**Addendum h to
ASHRAE Guideline 36-2018**

Proposed Addendum h to Guideline 36-2018, High-Performance Sequences of Operation for HVAC Systems

**First Public Review (February 2020)
(Draft shows Proposed Changes to Current Guideline)**

Addendum h to Guideline 36-2018

Figure 5.11.5-1. Control Logic for Snap-Acting Dual Duct VAV Zone (Transition to Cooling)

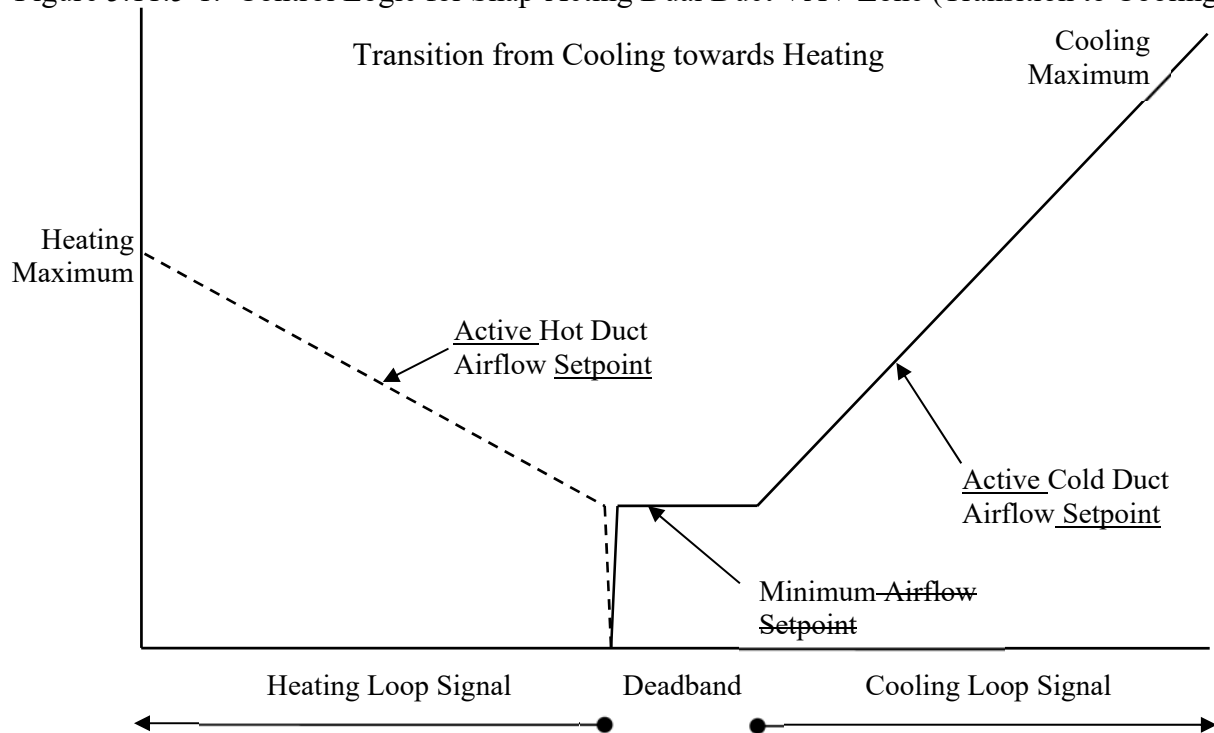
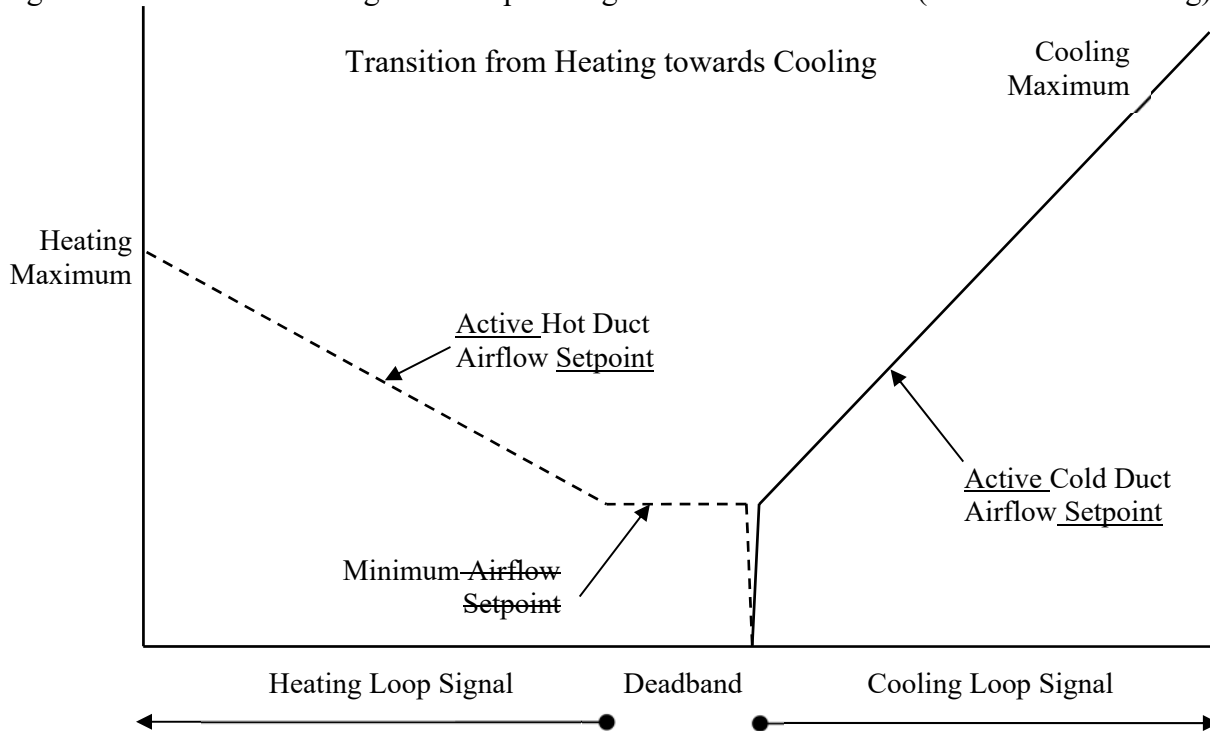
5.11.4 Active ~~maximum and minimum setpoints~~ endpoints used in the control logic depicted in Figures 5.11.5-1 and 5.11.5-2 shall vary depending on the Mode of the Zone Group the zone is a part of:

5.11.5 Control logic is depicted schematically in figures 5.11.5-1 and 5.11.5-2 below and described in the following sections. ~~Relative levels of various setups are depicted for Occupied Mode operation.~~

1. When the Zone State is Cooling, the Cooling Loop output shall reset the active cold duct cooling supply airflow setpoint from the minimum endpoint to cooling maximum endpointsetpoints. The cooling damper shall be modulated by a control loop to maintain the measured cooling airflow at the active cold duct airflow setpoint. The hot ductheating damper shall be closed.

2. When the Zone State is Deadband, the active cold duct and hot ductcooling and heating airflow setpoints shall be their last setpoints just before entering Deadband. In other words, when going from Cooling to Deadband, the active cold ductcooling airflow setpoint is equal to the zone minimum endpoint and the active hot duct airflowheating setpoint is zero. When going from Heating to Deadband, the active hot ductheating airflow setpoint is equal to the zone minimum endpoint and the active cold duct airflowcooling setpoint is zero. This results in a snap-action switch in the damper setpoint as indicated in the figures above.

3. When the Zone State is Heating, the Heating Loop output shall reset the active hot ductheating supply airflow setpoint from the minimum endpoint to the heating maximum endpointsetpoints. The hot ductheating damper shall be modulated by a control loop to maintain the measured heating airflow at the active hot duct airflow setpoint. The cold ductcooling damper shall be closed.
 - a. If hot deck supply air temperature from air handler is less than room temperature, the active hot ductheating supply airflow setpoint shall be no higher than the minimum endpoint.

setpoint from the minimum endpoint to cooling maximum endpoint~~setpoints~~. The cold ductcooling damper shall be modulated by a control loop to maintain the measured discharge airflow at the active cold duct airflow setpoint. The hot ductheating damper shall be closed.

2. When the Zone State is Deadband, the active~~discharge~~ airflow setpoint shall be the zone minimum endpoint, maintained by the damper that was operative just before entering Deadband. The other damper shall remain closed. In other words, when going from Cooling to Deadband, the cold ductcooling damper shall maintain the discharge airflow at the zone minimum endpoint~~setpoint~~ and the heating damper shall be closed. When going from Heating to Deadband, the hot ductheating damper shall maintain the discharge airflow at the zone minimum endpoint~~setpoint~~ and the cold ductcooling damper shall be closed. This results in a snap-action switch in the active damper airflow setpoint as indicated in the ~~the~~ Figures 5.11.5-1 and 5.11.5-2 above.

3. When the Zone State is Heating, the Heating Loop output shall reset the active hot duct~~discharge~~ airflow setpoint from the minimum endpoint to heating maximum endpoint~~setpoints~~. The hot ductheating damper shall be modulated by a control loop to maintain the measured discharge airflow at the active hot duct airflow setpoint. The cold ductcooling damper shall be closed.

Figure 5.12.5. Control Logic for Mixing Dual Duct VAV Zone with Inlet Sensors

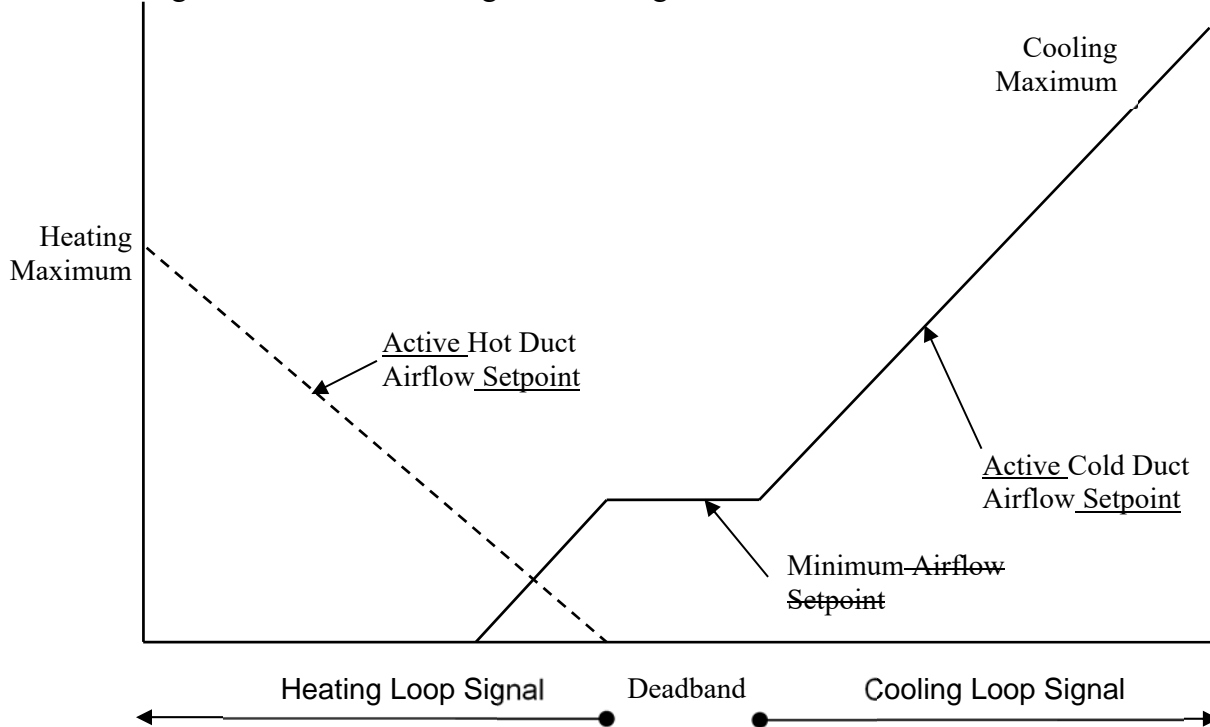
5.12.4 Active ~~maximum and minimum setpoints~~endpoints used in the control logic depicted in Figure 5.12.5 below shall vary depending on the Mode of the Zone Group the zone is a part of:

5.12.5 Control logic is depicted schematically in the figures below and described in the following sections.
~~Relative levels of various setpoints are depicted for Occupied Mode operation.~~

1. When the Zone State is Cooling, the Cooling Loop output shall reset the active cold duct cooling supply airflow setpoint from minimum endpoint to the cooling maximum endpoint~~maximum cooling setpoint~~. The cooling damper shall be modulated by a control loop to maintain the measured cold duct cooling airflow at active cold duct airflow setpoint.
 - a. If cold duct~~deck~~ supply air temperature from air handler is greater than room temperature, the active cold duct cooling supply airflow setpoint shall be no higher than the minimum endpoint.
2. When the Zone State is Deadband, the active cold duct cooling airflow setpoint shall be the minimum endpoint~~setpoint~~. The cooling damper shall be modulated by a control loop to maintain the measured cooling airflow at the active cold duct airflow setpoint. The hot duct~~heating~~ damper shall be closed.

3. When the Zone State is Heating, the Heating Loop output shall reset the active hot duct heating supply airflow setpoint from zero to the maximum heating maximum endpoint~~setpoint~~. The heating damper shall be modulated by a control loop to maintain the measured hot duct heating airflow at the active hot duct airflow setpoint. The cold duct cooling damper shall be controlled to maintain the sum of the measured inlet airflows at the minimum endpoint~~airflow setpoint~~.

Figure 5.13.5. Control Logic for Mixing Dual Duct VAV Zone with Discharge Sensor

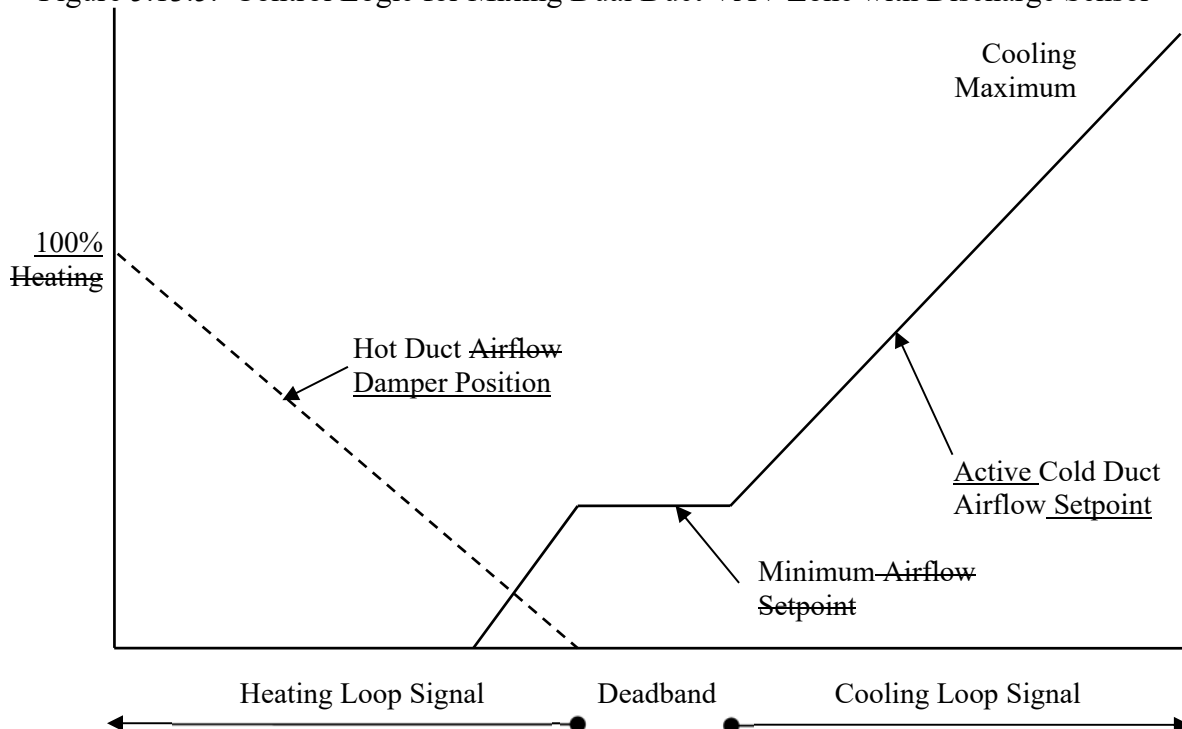
1. Updated airflow setpoint tables in Sections 5.5 through 5.14.
2. Updated control logic figures 5.5.5 through 5.14.5 to be consistent with updated airflow setpoint tables.
3. Corrected Figure 5.13.5 for consistency with Section 5.13.
4. Updated control logic descriptions in Sections 5.5 through 5.14 to match updated terms.
5. For Dual Duct VAV Terminal Unit – Mixing Control with Discharge Airflow Sensor, removed hot duct static pressure reset requests based on airflow setpoint. Paragraphs 5.13.8.4.1 and 5.13.8.4.2.
6. For Dual Duct VAV Terminal Unit – Mixing Control with Discharge Airflow Sensor, changed the setpoint of the reverse-acting P-only maximum hot duct damper position limiting loop from Vheat-max to the heating maximum endpoint, which changes based on Zone Group Mode. Paragraph 5.13.1.3.b.

1. Distinguishes the differences between airflow setpoints which are determined by the designer and the endpoints used in control logic. This has been a source of confusion because the endpoints have similar names as the setpoints.
2. Corrects inconsistencies in Section 5.13 between variable names used in control logic and Figure 5.13.5.
3. Corrects inconsistencies in variable names throughout the guideline.

5.13.4 Active ~~maximum and minimum setpoints~~ endpoints used in the control logic depicted in Figure 5.13.5 below shall vary depending on the Mode of the Zone Group the zone is a part of:

5.13.5 Control logic is depicted schematically in figure 5.13.5 below and described in the following sections. ~~Relative levels of various setpoints are depicted for Occupied Mode operation.~~

1. When the Zone State is Cooling, the Cooling Loop output shall reset the active cold duct ~~cooling~~ supply airflow setpoint from minimum endpoint to the maximum-cooling ~~maximum endpoint~~ setpoint. The cold duct~~cooling~~ damper shall be modulated by a control loop to maintain the measured cold duct~~cooling~~ airflow at the active cold duct airflow setpoint.

2. When the Zone State is Deadband, the active cold duct~~cooling~~ airflow setpoint shall be the minimum ~~endpoint~~ setpoint. The cold duct~~cooling~~ damper shall be modulated by a control loop to maintain the measured cold duct~~cooling~~ airflow at the active cold duct airflow setpoint. The hot duct~~heating~~ damper shall be closed.

3. When the Zone State is Heating, the Heating Loop output shall be mapped to the hot duct~~heating~~ damper position. The cold duct~~cooling~~ damper is modulated to maintain measured discharge airflow at the minimum endpoint~~airflow~~ setpoint.
 - a. If hot duct~~deck~~ supply air temperature from air handler is less than room temperature, hot duct~~heating~~ damper shall be closed.
 - b. Maximum hot duct~~heating~~ airflow shall be limited by a reverse-acting P-only loop whose setpoint is the heating ~~maximum endpoint~~ $V_{heat-max}$ and whose output is maximum hot duct~~heating~~ damper position ranging from 0% to 100%.

Since the hot duct~~heating~~ damper is operating on a pressure-dependent manner, a loop must be added to limit hot duct~~heating~~ damper position to the heating ~~maximum endpoint~~ $V_{heat-max}$. When this comes into play, the only air going through the discharge airflow sensor is heating air.

Figure 5.14.5. Control Logic for Mixing Dual Duct VAV Zone with Cold Duct Minimum

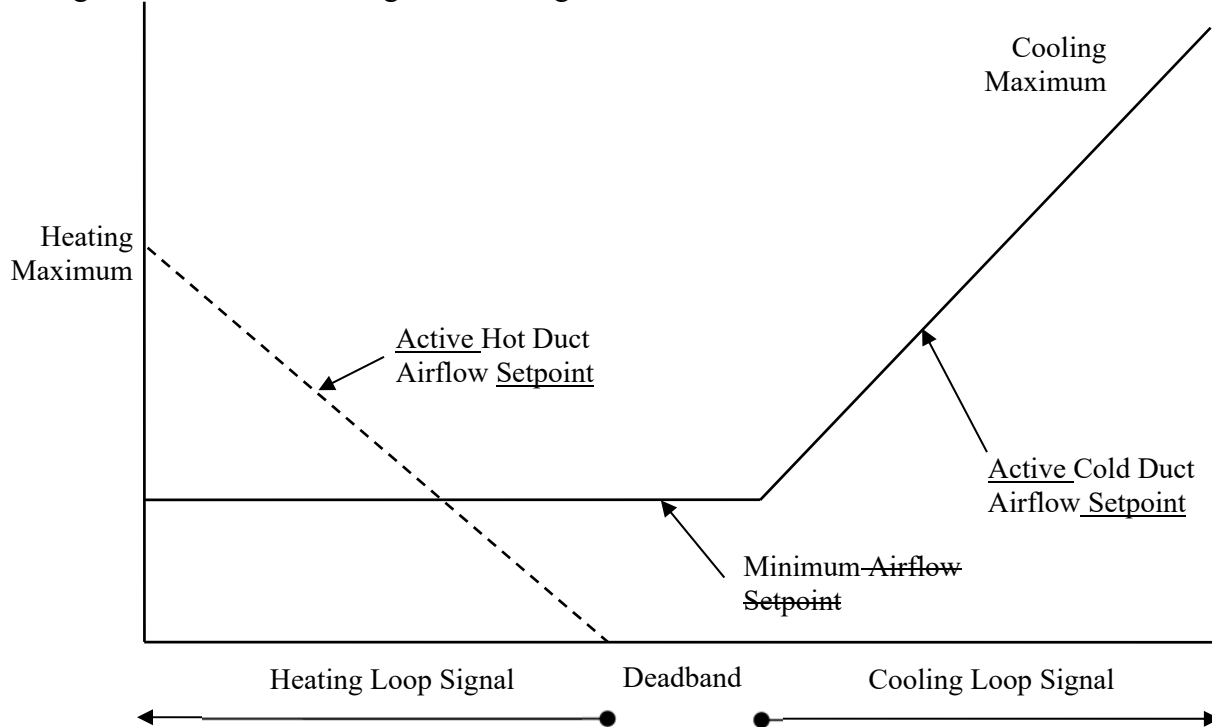
5.14.4 Active ~~maximum and minimum setpoints~~ endpoints used in the control logic depicted in Figure 5.14.5 below shall vary depending on the Mode of the Zone Group the zone is a part of:

5.14.5 Control logic is depicted schematically in figure 5.14.5 below and described in the following sections. ~~Relative levels of various setpoints are depicted for Occupied Mode operation.~~

1. When the Zone State is Cooling, the Cooling Loop output shall reset the active cold duct cooling supply airflow setpoint from the minimum endpoint to cooling maximum endpoint setpoints. The cold duct cooling damper shall be modulated by a control loop to maintain the measured cold duct cooling airflow at the active cold duct airflow setpoint. The hot duct heating damper shall be closed.

2. When the Zone State is Deadband, the active cold duct cooling airflow setpoint shall be the minimum endpoint setpoint. The cold duct cooling damper shall be modulated by a control loop to maintain the measured cold duct cooling airflow at the active cold duct airflow setpoint. The hot duct heating damper shall be closed.

3. When the Zone State is Heating,
 - a. The Heating Loop output shall reset the active hot duct heating supply airflow setpoint from zero to heating maximum endpoint setpoint. The hot duct heating damper shall be modulated by a control loop to maintain the measured hot duct heating airflow at the active hot duct airflow setpoint.

- b. The active cold duct cooling airflow setpoint shall be the minimum endpoint setpoint. The cold duct cooling damper shall be modulated by a control loop to maintain the measured
